# Technical Service Bulletin

**NUMBER:** 03-05-00

**DATE:** July 21, 2000

Quality Improvements To Address Front Axle Whine And 2,400 RPM Moan

**FIGURE 2**

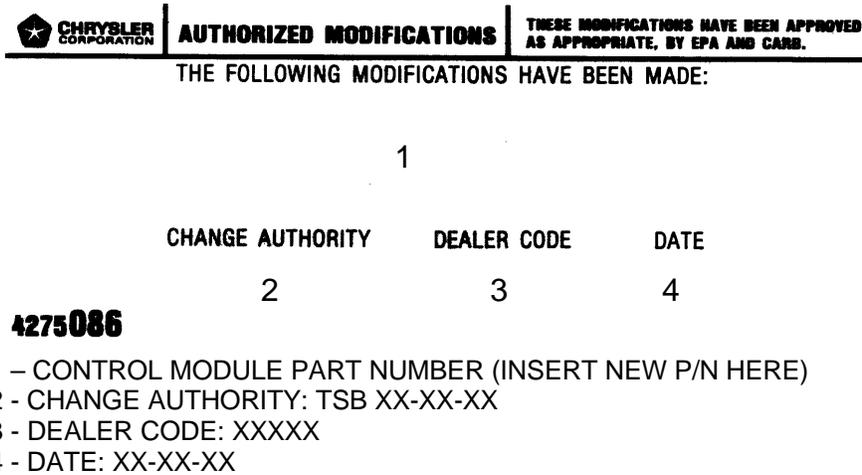
- 10. Type the necessary information on the “Authorized Modification Label” p/n 04275086 and attach the label near the VECI label (Figure 2).
